DEVELOPMENT REVIEW BOARD
SUPPLEMENTAL SUBMITTAL

PROJECT NO. PR-2021-006238
Application No. SI-2021-01916 and SD-2022-00001

Memorandum

Re: Allaso Louisiana Site Plan – DRB Comment Responses (PR-2021-006238)

LS-01

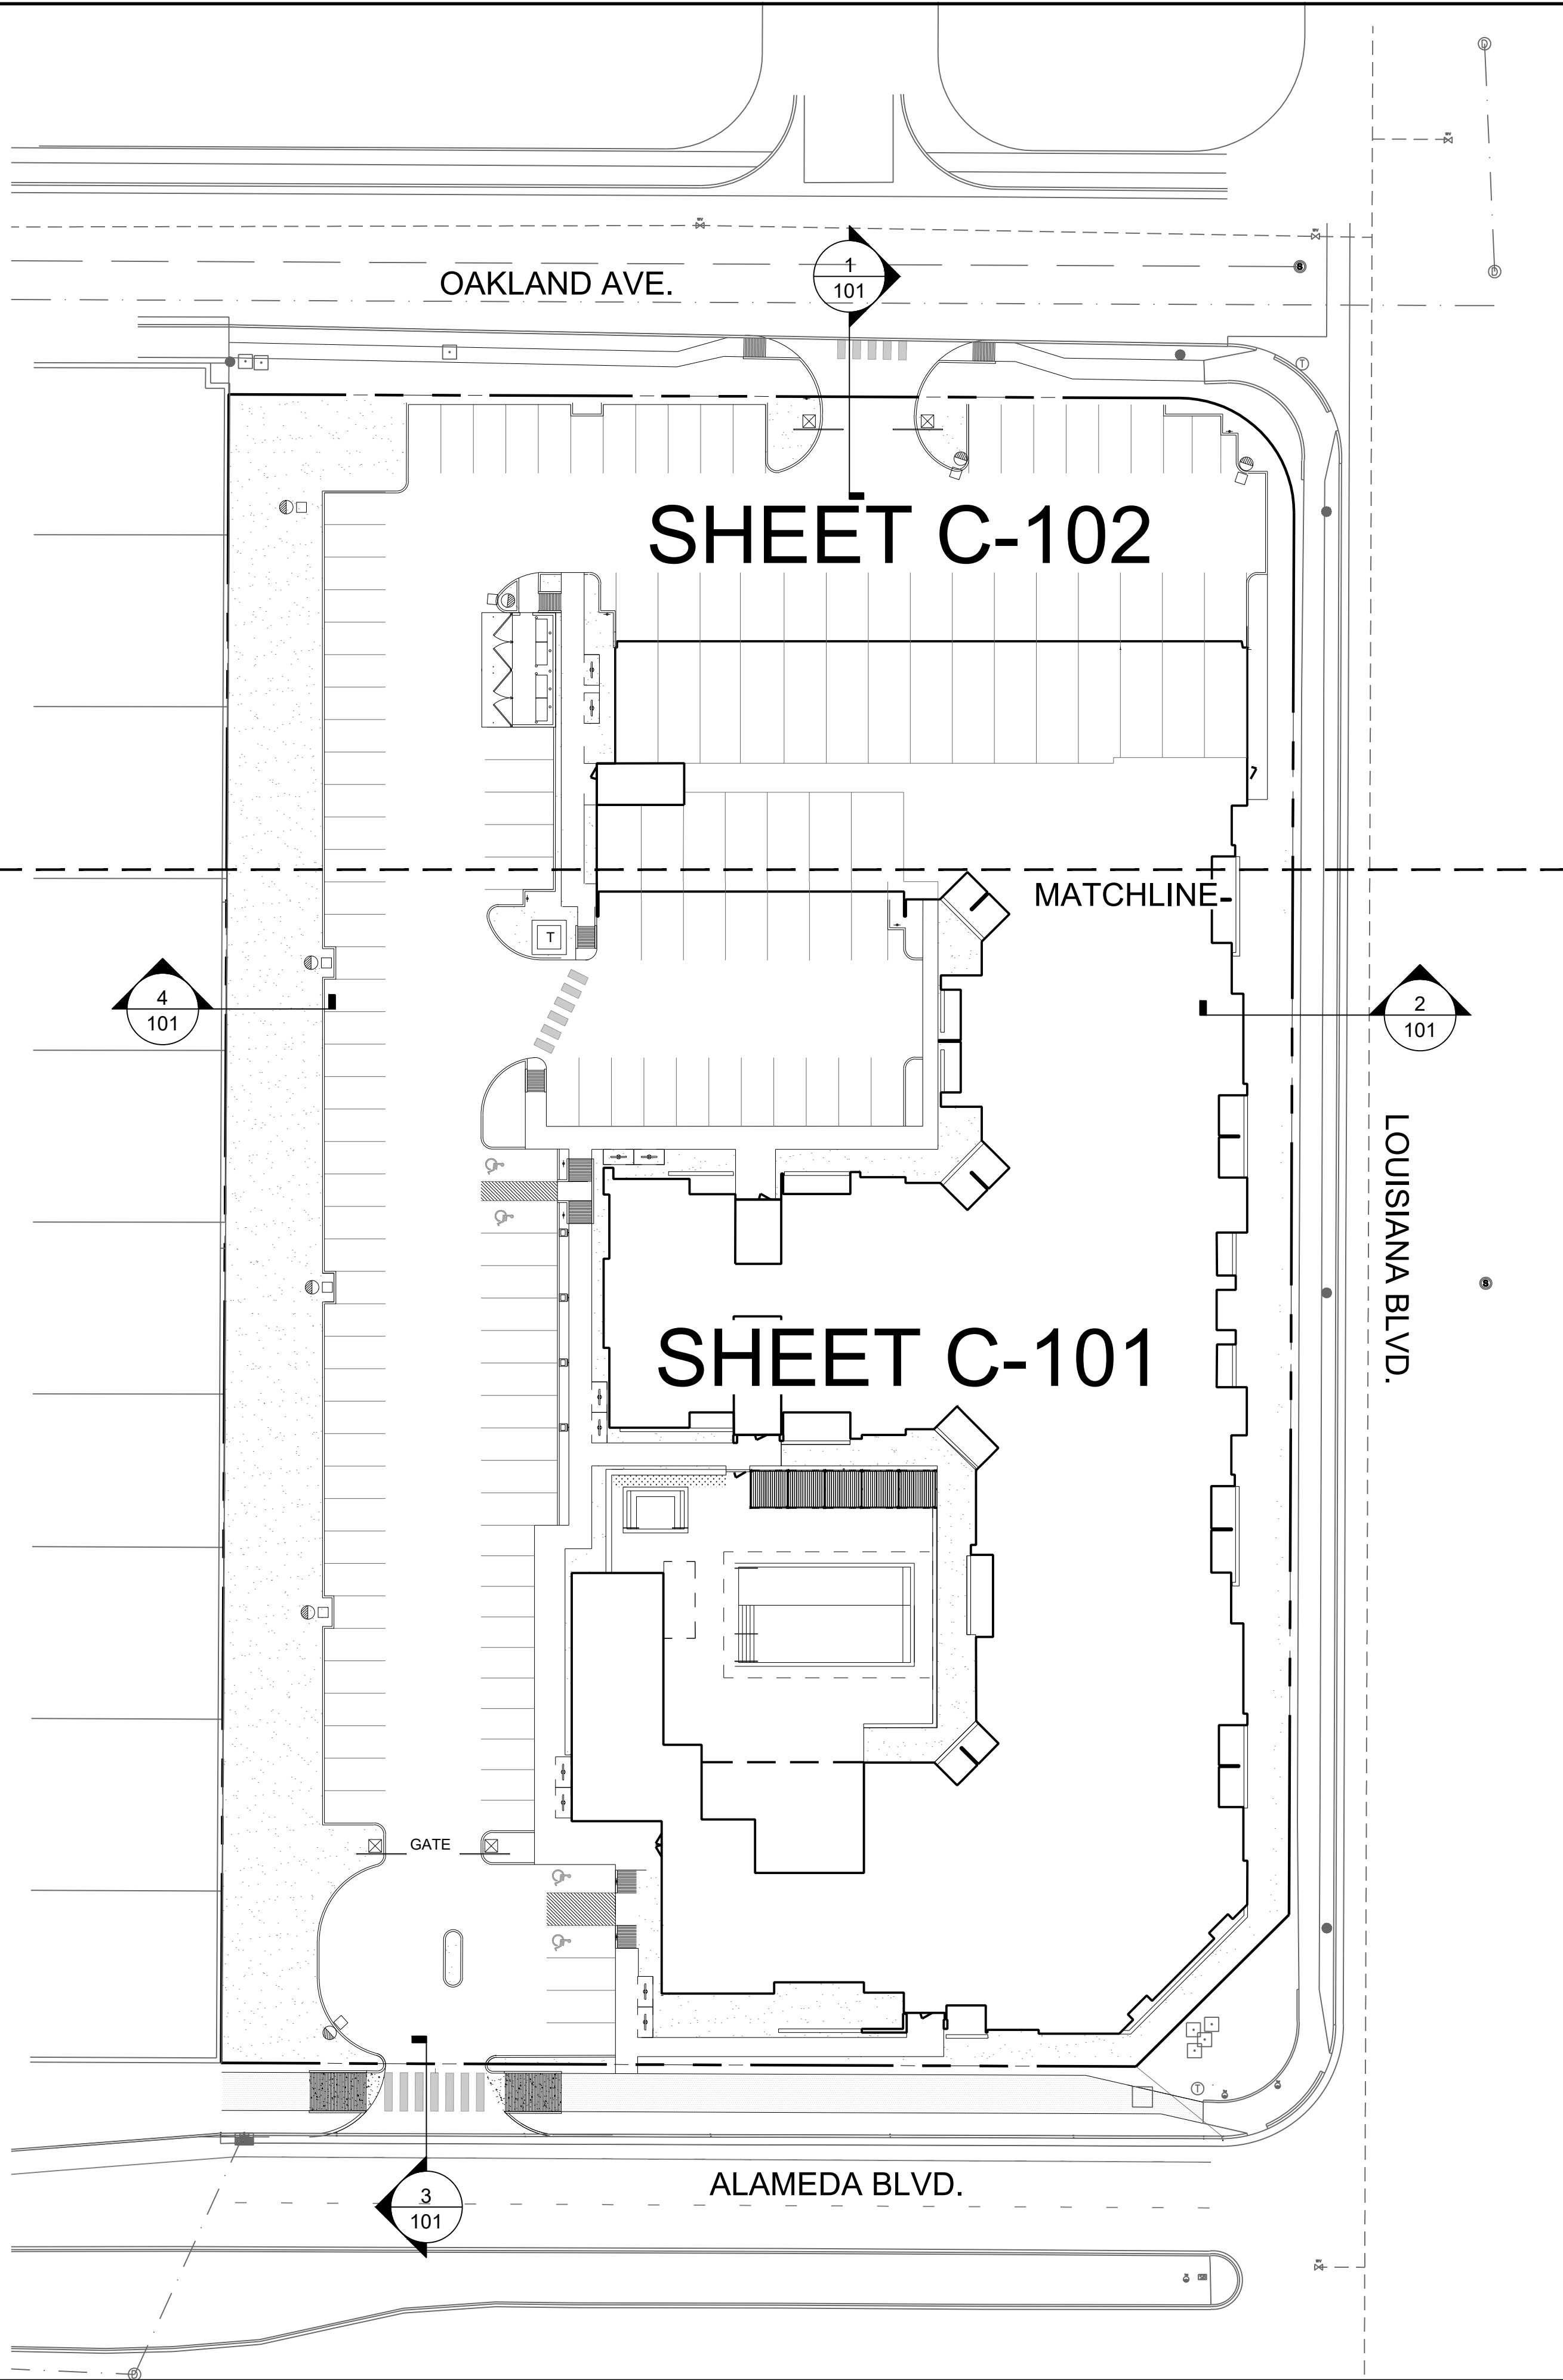
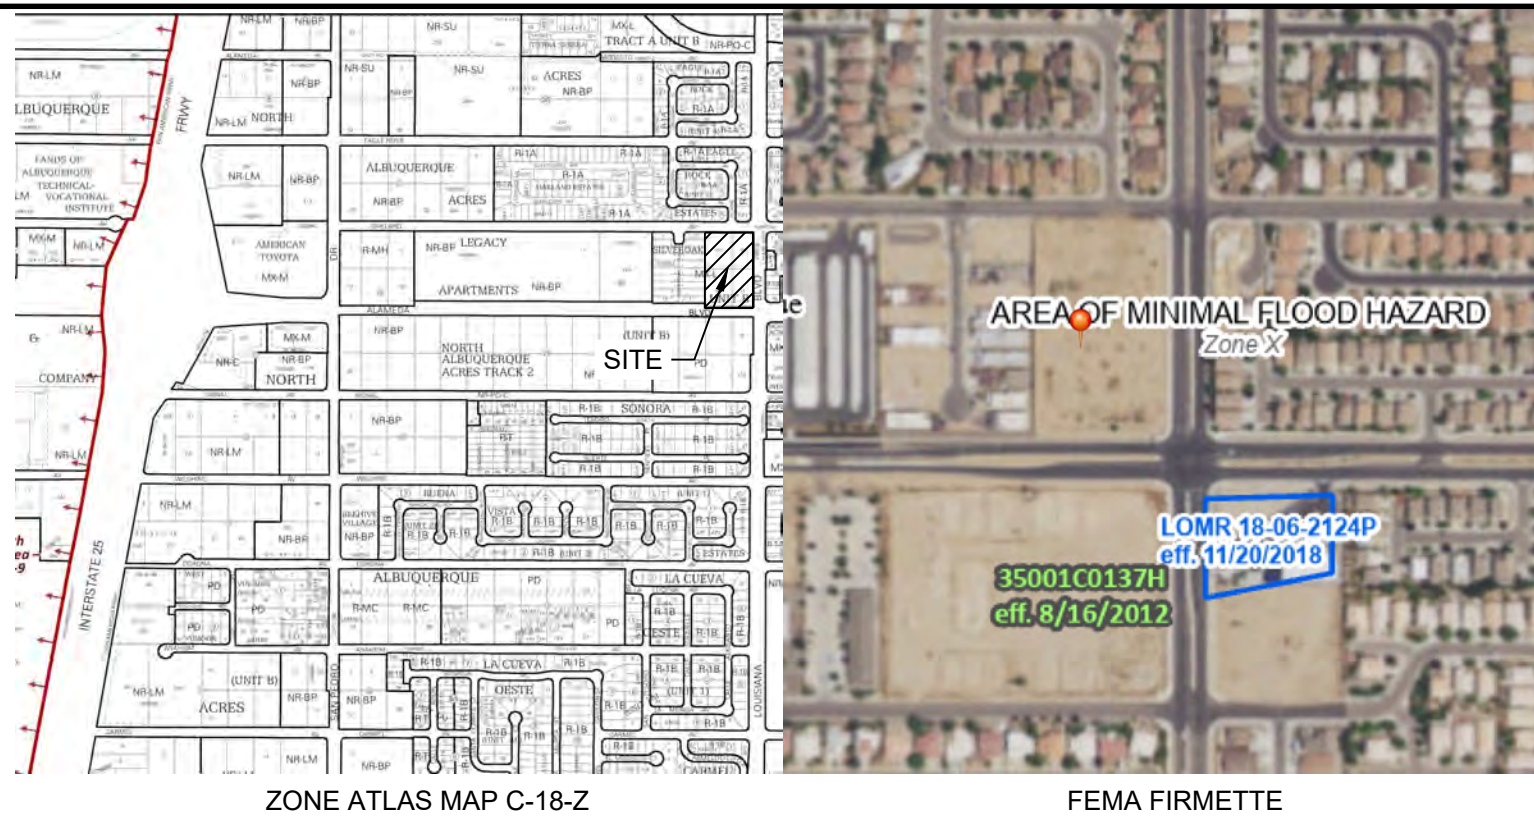
1. Label clear sight triangles with a keyed note on the landscaping plan for both entrance locations.
 - a. ***A keynote has been added to the landscape plan for the clear sight triangles.***

4. Utility Plan:
 - a. There shall be no trees, parallel fences/sidewalks/curbs, or structures within the public water and public sewer easement. Please revise landscape plan in the area of the water meter vault.
 - a. ***The landscape plan has been updated to further adjust the landscaping around and within the easement area.***

- CLEAR SIGHT TRIANGLE.
